Subject: CESSAR Amendment 10

As a result of startup testing conducted at Palo Verde on the first System 80™ plant, C-E has identified changes to CESSAR. These proposed changes are described in the attachment and are provided for NRC Staff review.

## SUMMARY OF CHANGES

Figure  
5.2-1

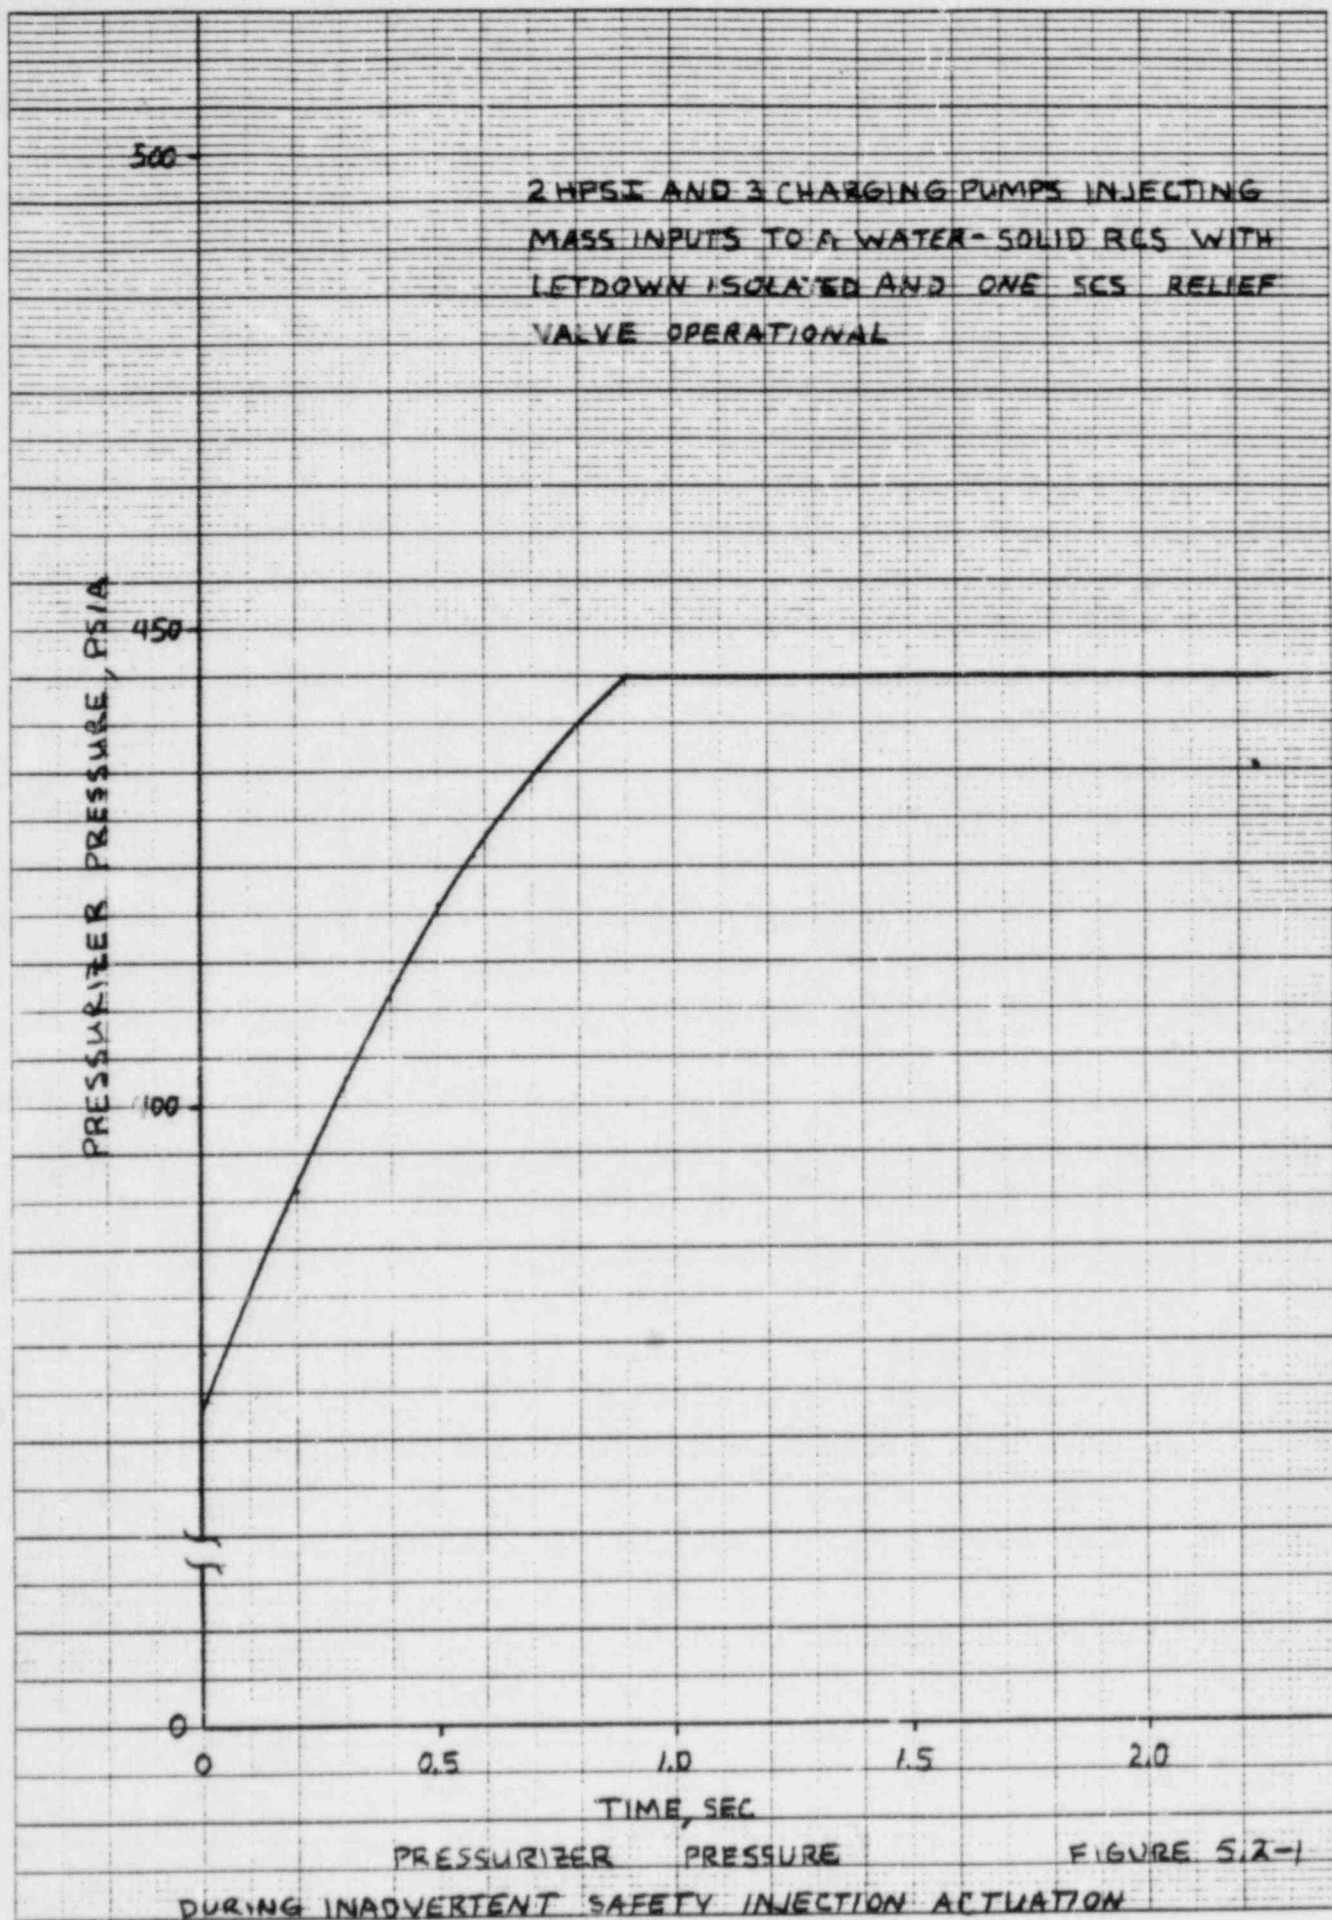
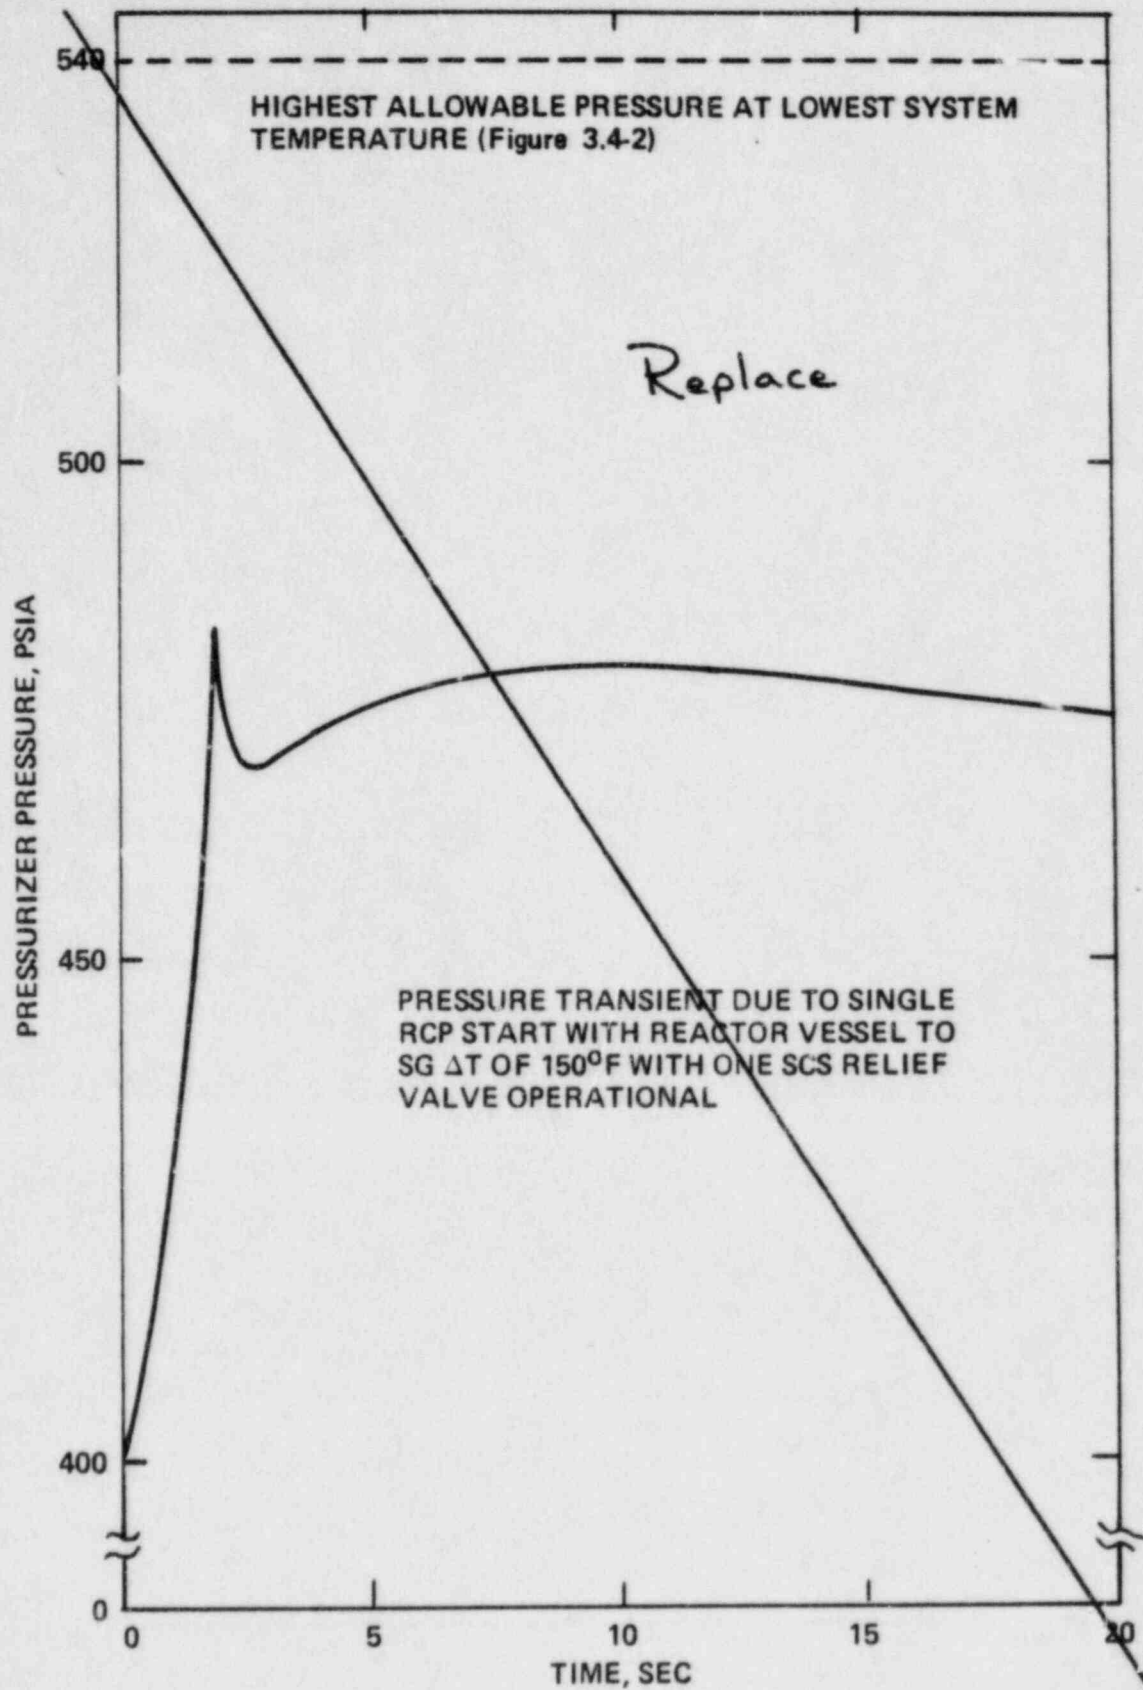
Figure 5.2-1 is modified to credit the typical difference in height between the pressurizer and the shutdown cooling system. This change was also made to provide operational flexibility.

Figure 5.2-1 shows the result of the inadvertent safety injection actuation transient analysis when the RCS is in the LTOP mode. The mass addition due to the simultaneous operation of two HPSI and three charging pumps was considered, along with the simultaneous addition of energy from decay heat and the pressurizer heaters.

Figure  
5.2-2

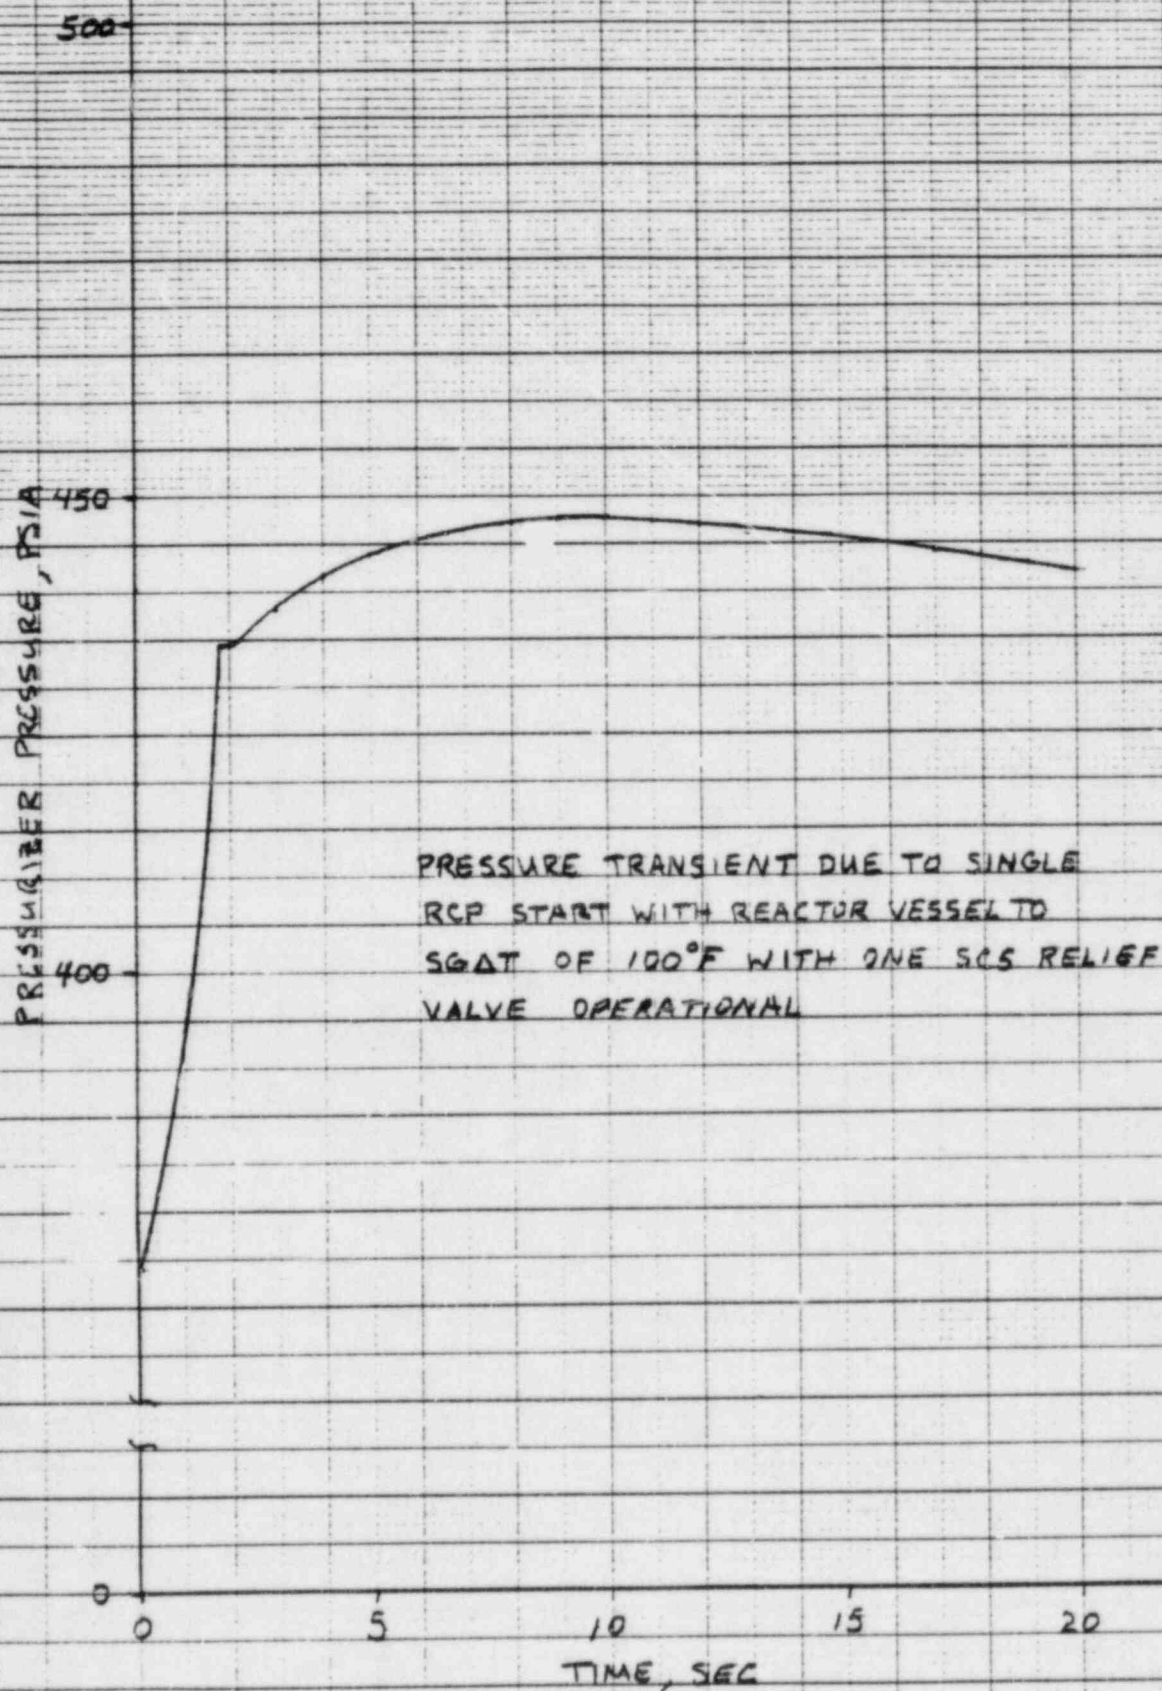
Section 5.2.2.10 and Figure 5.2-2 are changed to reflect a lower maximum  $\Delta T$  across a steam generator. This change is made to allow additional operational flexibility and limits the maximum  $\Delta T$  at which a Reactor Coolant Pump can be started to 100°F. Additionally, clarification is added to more accurately reflect the Shutdown Cooling System relief valves used in construction.

Figures 5.2-2 shows the result of the transient analysis of a reactor coolant pump start when a steam generator to reactor vessel  $\Delta T$  of ~~150°F~~ exists. This  $\Delta T$  is ~~considered greater than any that can possibly occur in the system during the LTOP mode.~~ In addition to considering the energy addition to the RCS from the steam generator secondary side, energy addition from decay heat, the reactor coolant pump and all pressurizer heaters were also included. In this analysis the steam generators were assumed to be filled to the zero power, normal water level. For conservatism, the secondary water, both around and above the U-tubes, was assumed to be thermally mixed in order to maximize the energy input to the primary side. This assumption is conservative since as a result of the temperature distribution within the steam generator during the transient, the water inventory above the tubes is practically isolated thermally from the heat transfer region. Therefore the heat transfer rate, and thus the primary side pressure, is not sensitive to the secondary side water level as long as the tubes are covered.

On the basis of experience, the  $\Delta T$  value of ~~150°F~~ used in the analysis is much larger than any  $\Delta T$  that might be expected during plant operation. This maximum allowable  $\Delta T$  of ~~150°F~~ will prevent pressurizer pressure from exceeding the minimum P-T limit (~~approximately 540 psia~~) allowed for the lowest system temperature during the LTOP mode of operation. (See Technical Specification Figure 3.4-2). During RCS cooldown using the shutdown cooling system, coolant circulating with the reactor coolant pumps serves to cool the steam generator to keep the temperature difference between the reactor vessel and the steam generator minimal. Procedures will direct the operator to maintain the  $\Delta T$  below approximately 20°F.

Figure  
6.3.3.  
2-5L

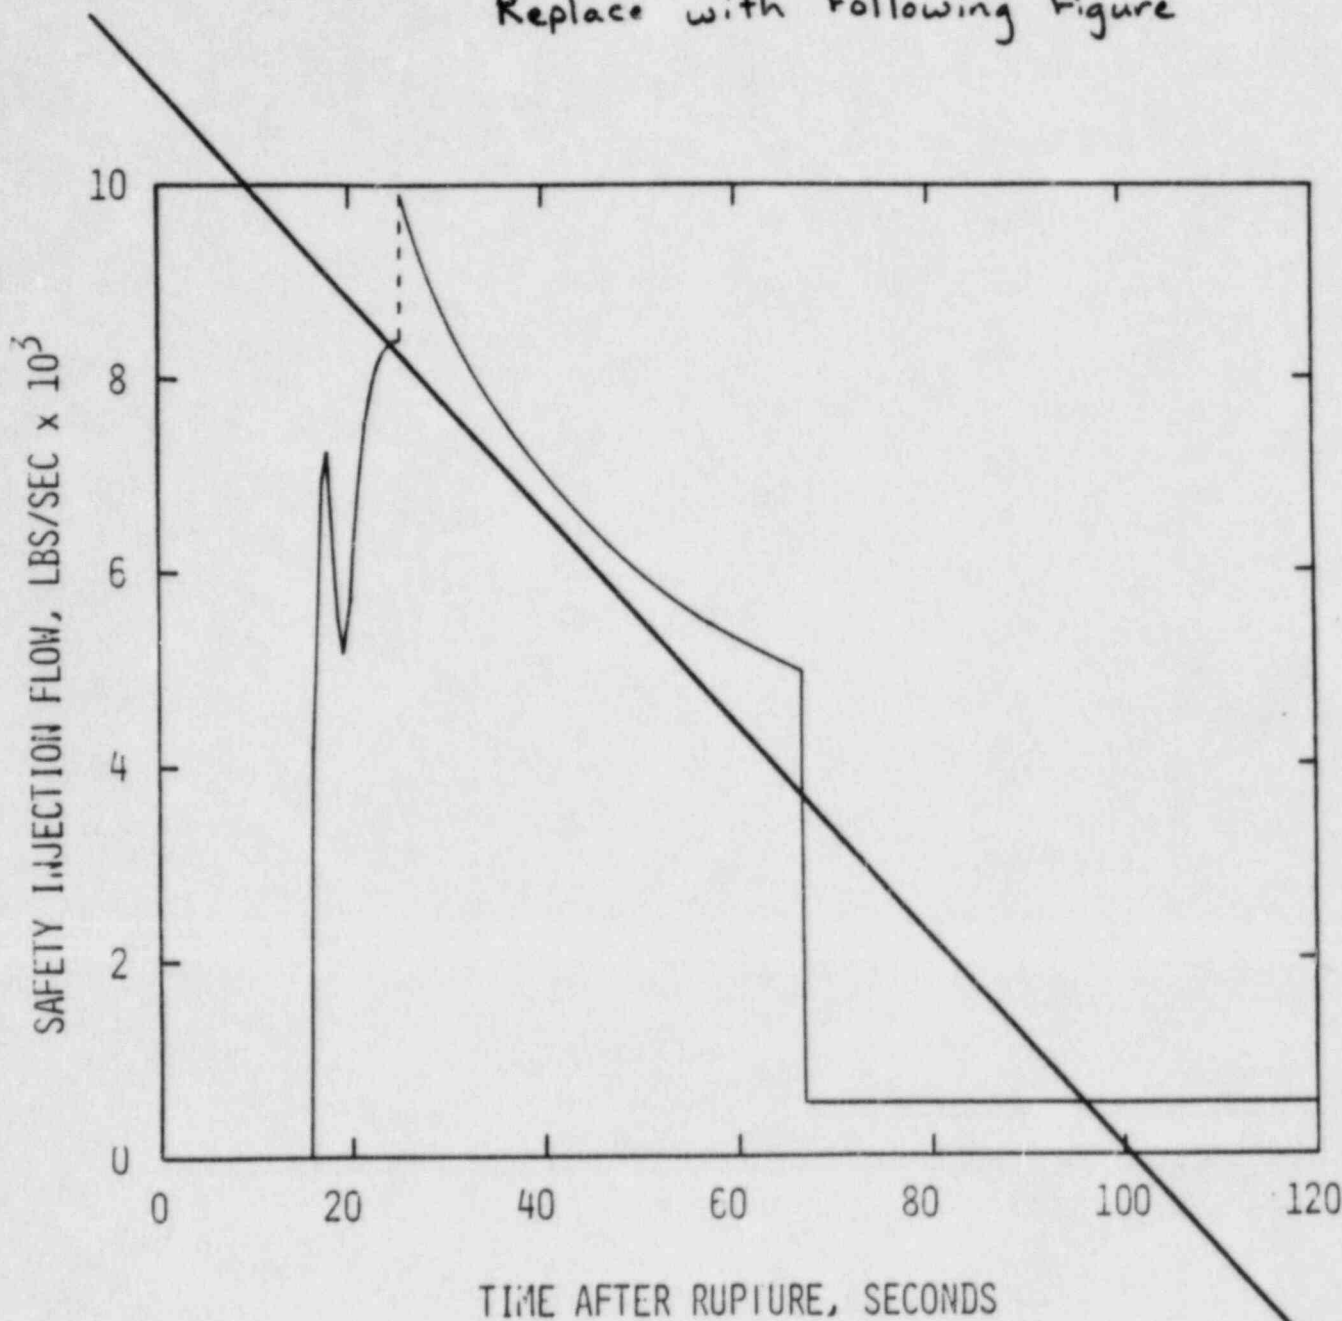
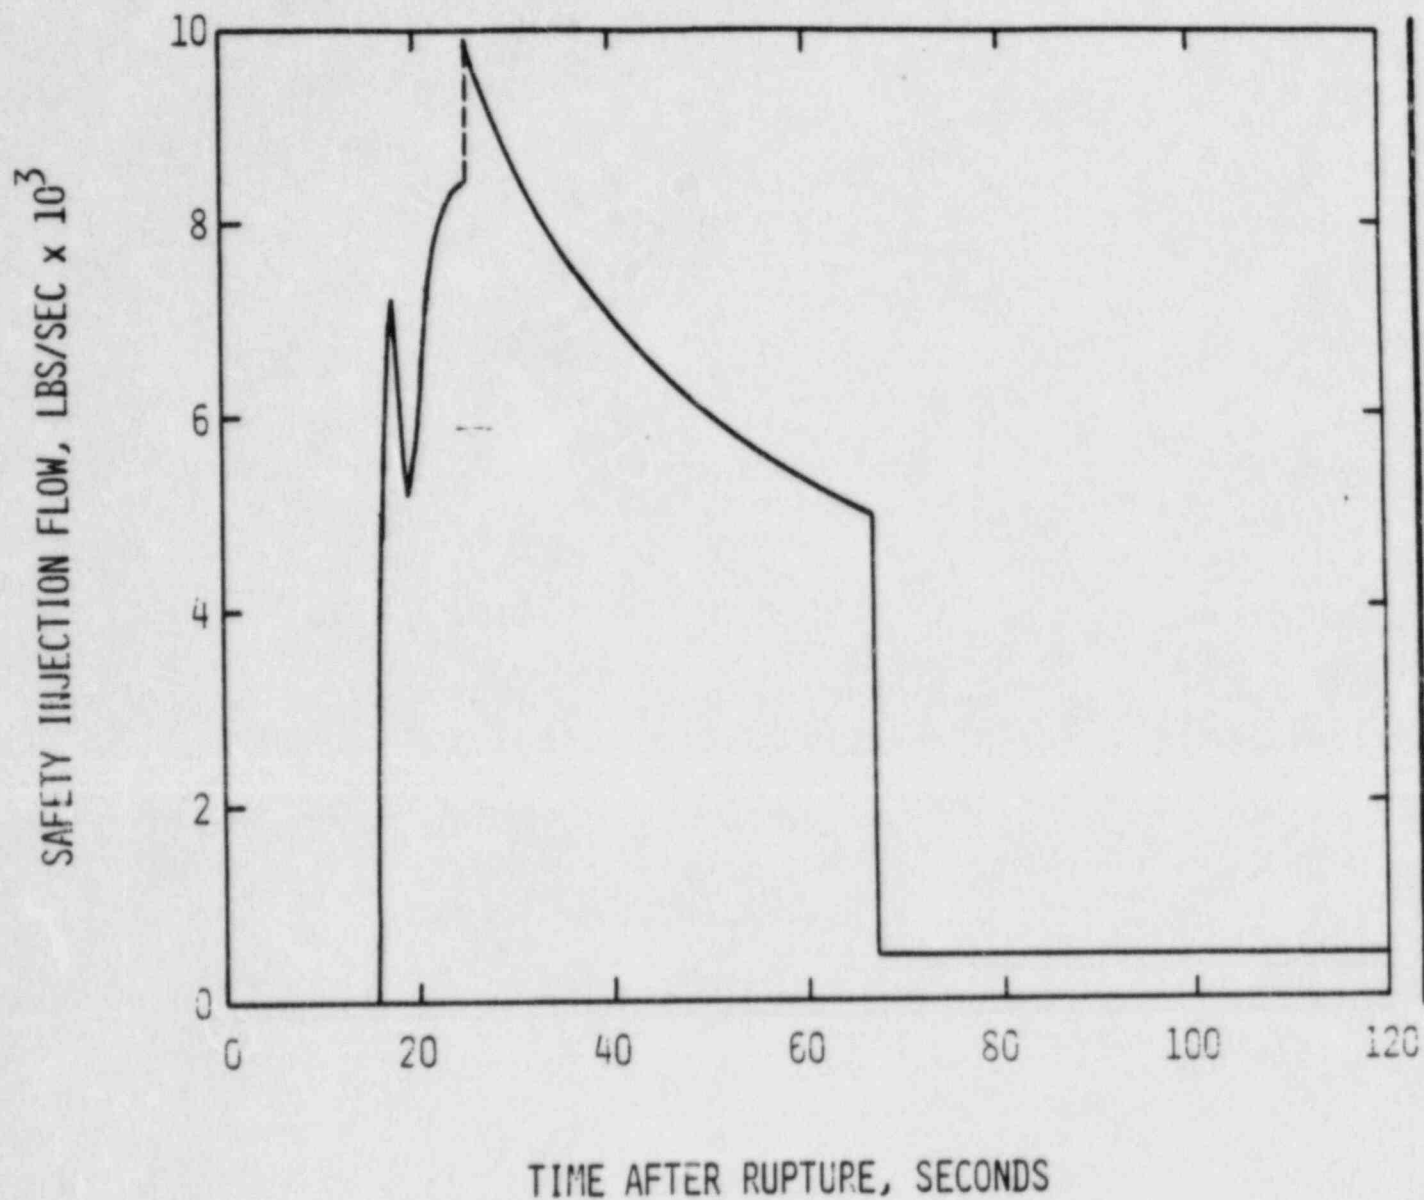
Tables 6.3.3.3-1 and 6.3.3.3-2, and Figure 6.3.3.2-5L, are modified to ease Low Pressure Safety Injection flow requirements. These flow changes were found to be sufficient to preserve the present ECCS performance results. Comparison of the revised figure with the figure currently in CESSAR demonstrates the insignificance of this change on the worst case postulated break.

Replace with following Figure
